**NRC Concerns Relating to  
Steam Generators at  
Indian Point Unit 2**

**Public Meeting with ConEd  
July 21, 1998<sup>9</sup>**

## Staff Concerns Identified in July 20, 2000 Letter

Figure 8-7  
SG 4, U-Bend Tube R2C74, Crack Depth Profiles  
Comparison of 800 kHz Pre and Post In Situ Test  
NDE Depth vs. Axial Length

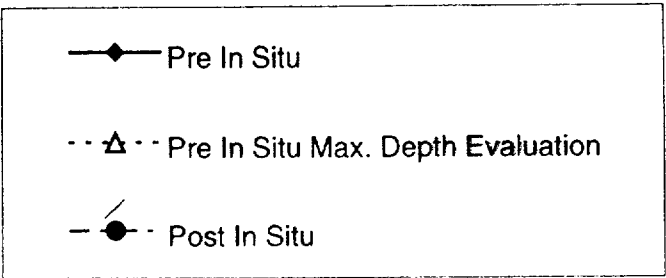
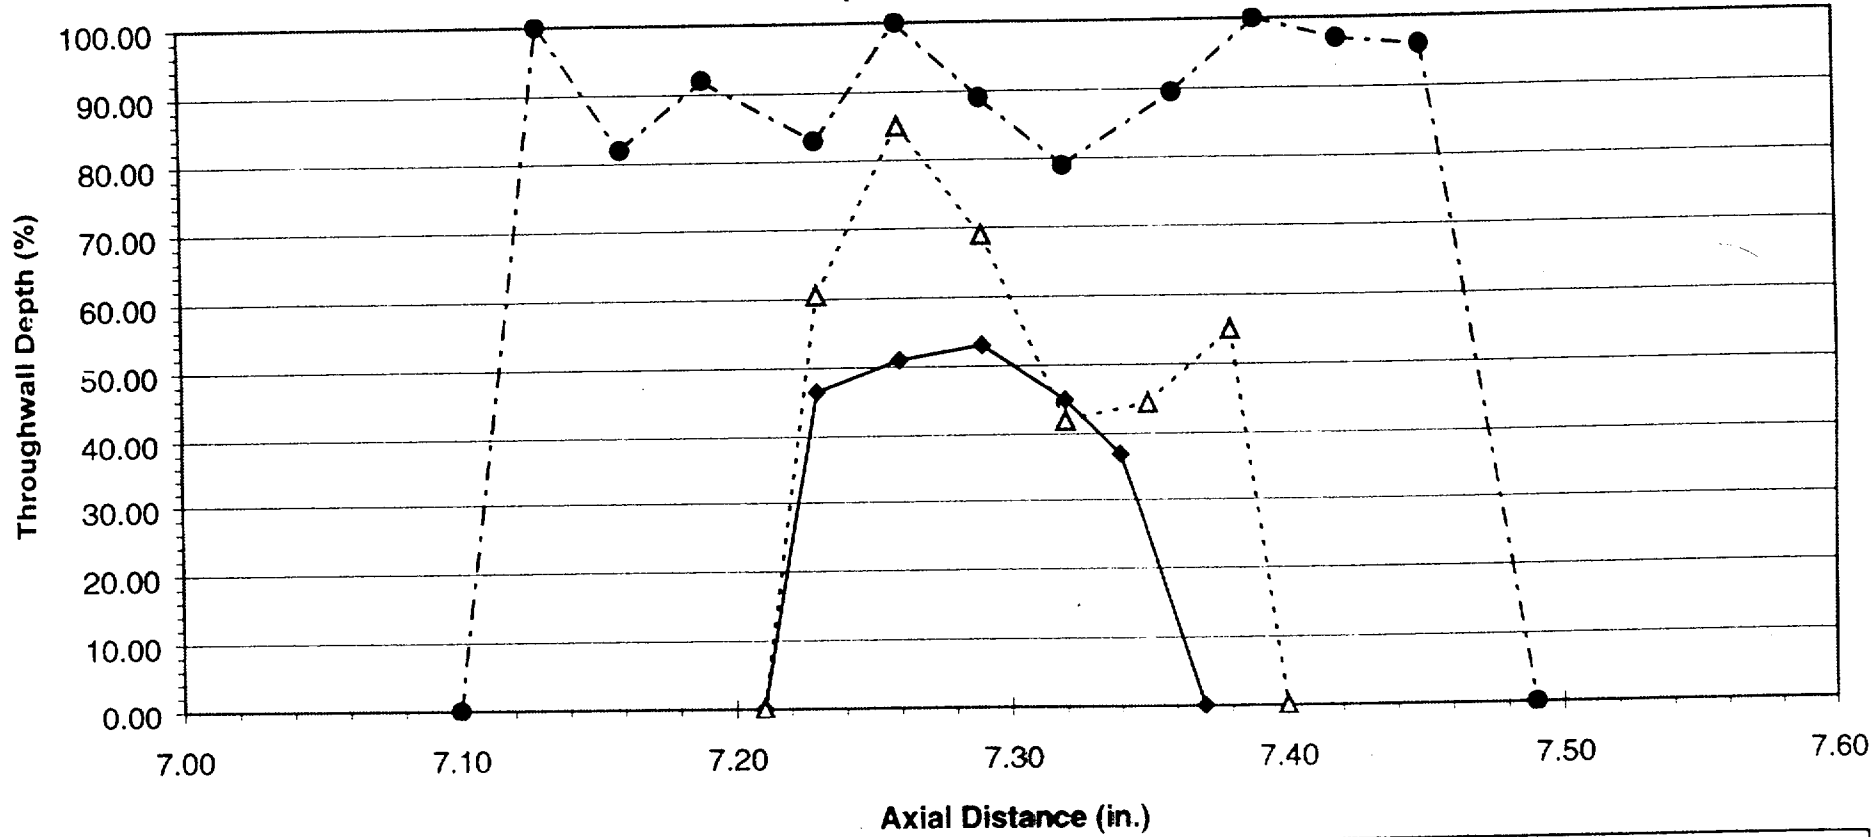
- The assumed flaw size measurement error distribution associated with use of the mid-range and high frequency plus-point probes in the IP-2 u-bends has not been validated.
- Assumed measurement errors are based on performance demonstration data for the mid-range plus-point probe at tube dents.
- The staff is concerned that this assumption lacks technical justification and is potentially non-conservative due to differences in tube geometry, surface deposits, and signal to noise ratios.

Figure C.1-11

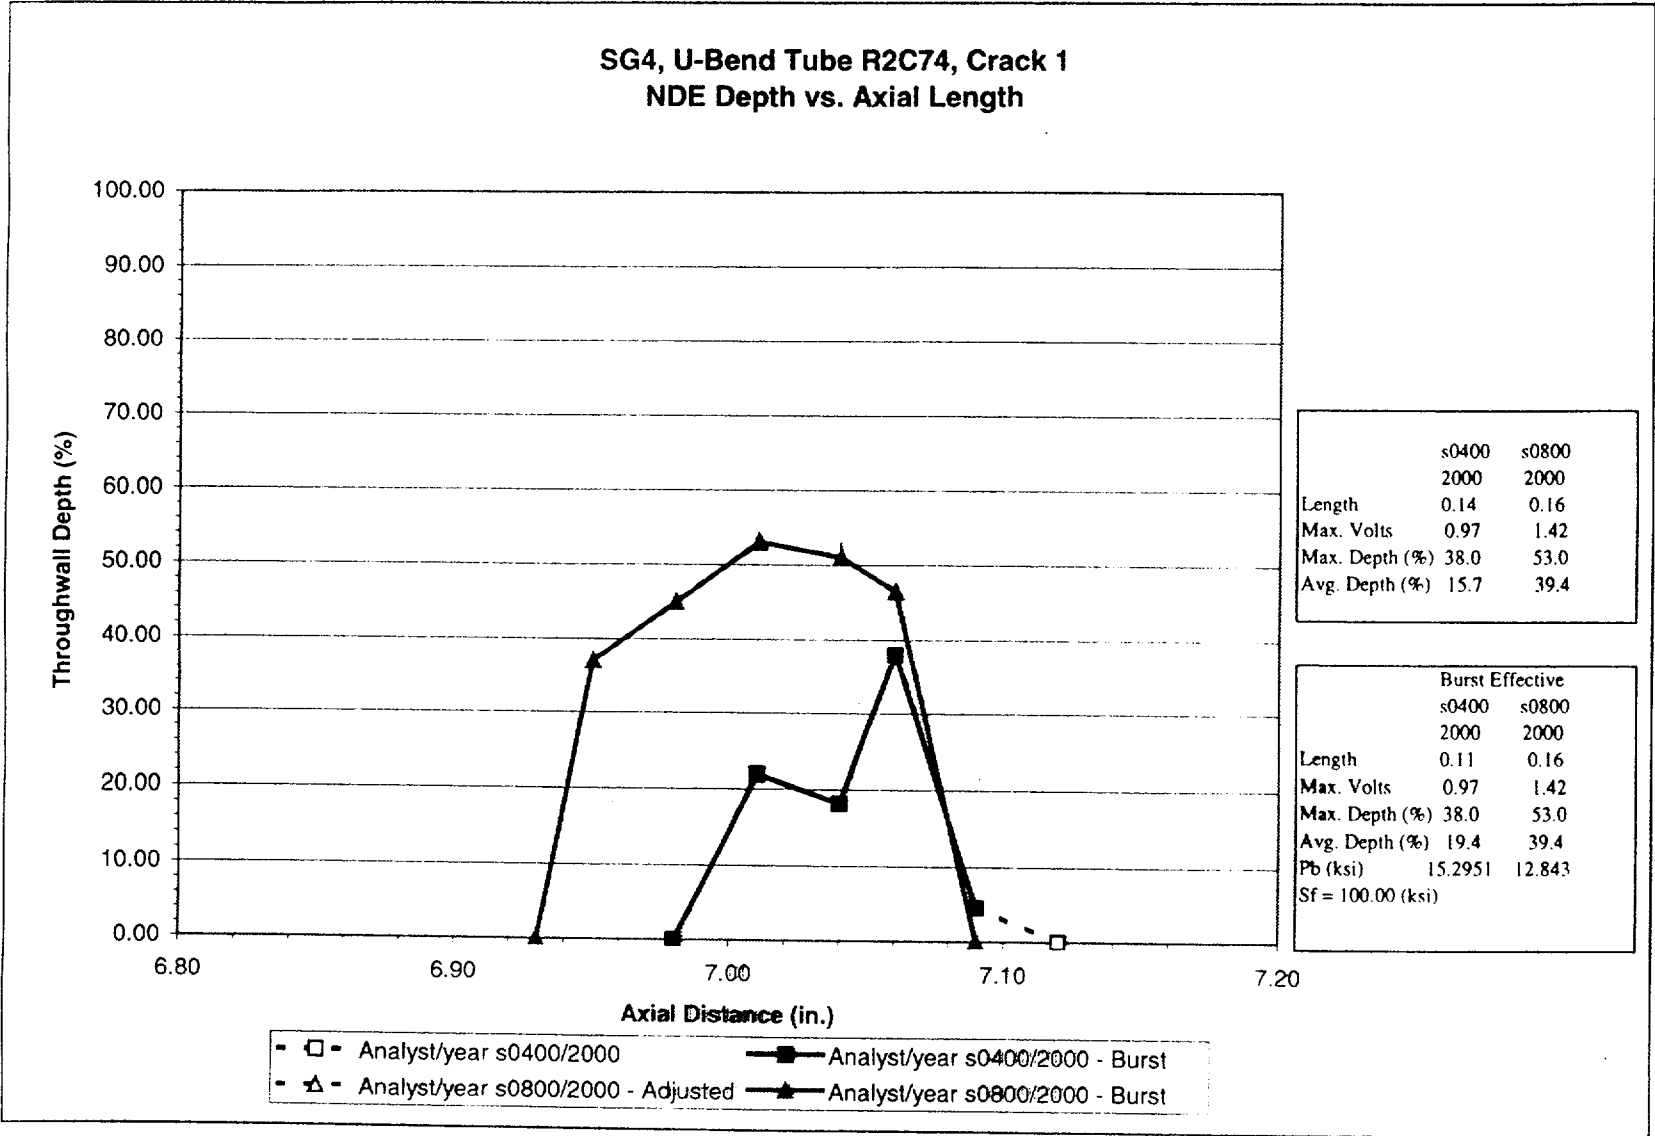
- The above concerns notwithstanding, the staff considers flaw sizing measurements based on the high frequency probe 800 KHz data to be more accurate than those based on the mid-range probe 400 KHz data due to significantly improved signal to noise.
  - Burst pressure estimates based on the 800 KHz flaw size measurements are 18% lower than those based on the 400 KHz measurements. Licensee needs to explain why its analysis appears insensitive to which set of measurements is used.
- The staff believes the results of the licensee's analyses are very sensitive to the assumed measurement error distribution. These distributions are used to estimate the number and size of flaws which may remain undetected in tubes which are still in service.
